NSLPP MEETING HELD ON 01/03/2023

ADDRESS/WARD: 4 Honda Road, Kurraba Point

APPLICATION No: 130/22

PROPOSAL: Subdivision into two lots, construction of a new dwelling, stormwater works and alterations and additions to an existing dwelling

Figure 7 – Annotated House 1 West Elevation (DA 15 Rev B)

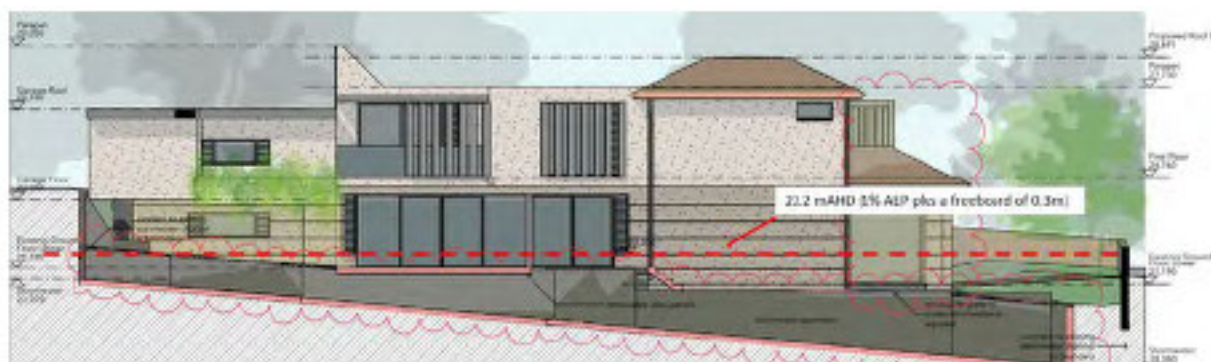
- House 1 (West Elevation) which is adjacent to the stormwater channel primarily proposes blank walls and windows at 22.2 mAHD. Window W02 and W08 are to be designed to be flood resistant subject to condition of consent (refer to Condition C15 Amendments to House 1 Fenestration – Flooding).

Figure 11 – Annotated House 1, Section 02 (DA13 Rev B)

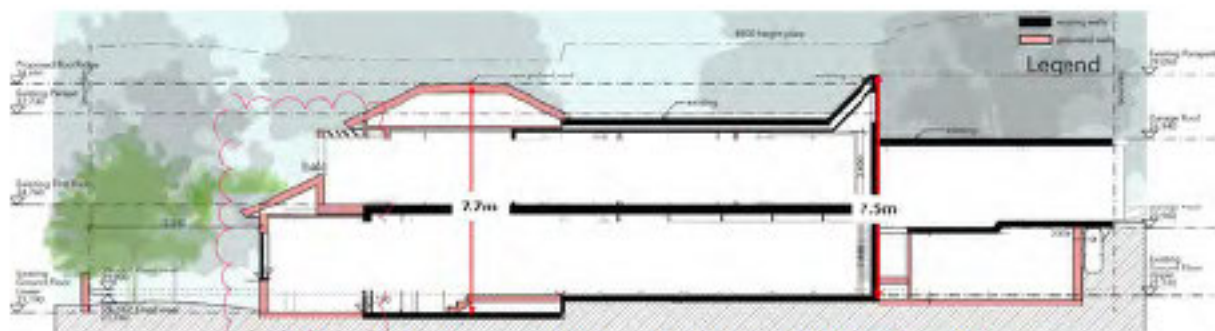
House 1 located in the eastern part of the site will have a height complying with the maximum 8.5m height limit.

Figure 12 – Annotated House 2, Section 01 (DA20 Rev B)

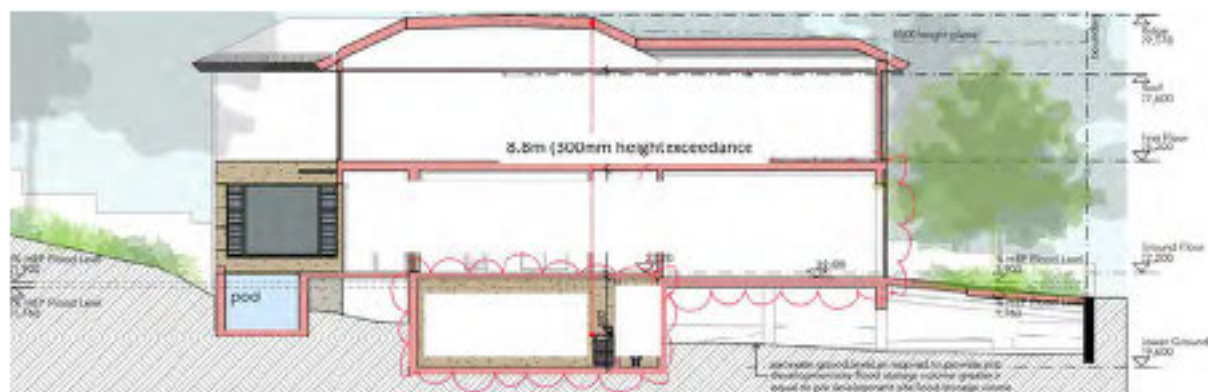
House 2 will have a height of 8.8m (RL 29,178) with an exceedance of 300mm (3.5%) not complying with the permissible height limit of 8.5m, not in accordance with clause 4.3 in NSLEP 2013.

Figure 18 – Height Plane Diagram from South and Honda Street – DA31 Rev B

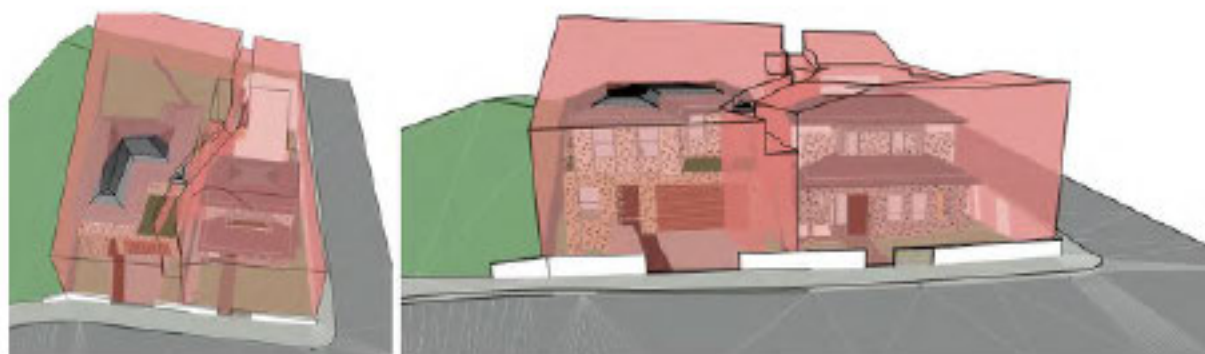
The height exceedances for House 2 relates to parts of the dwelling roof therefore the height exceedance has no direct impact on the privacy of adjoining properties. The height plane diagrams shown below confirm that the height exceedance relates to parts of the roof only.
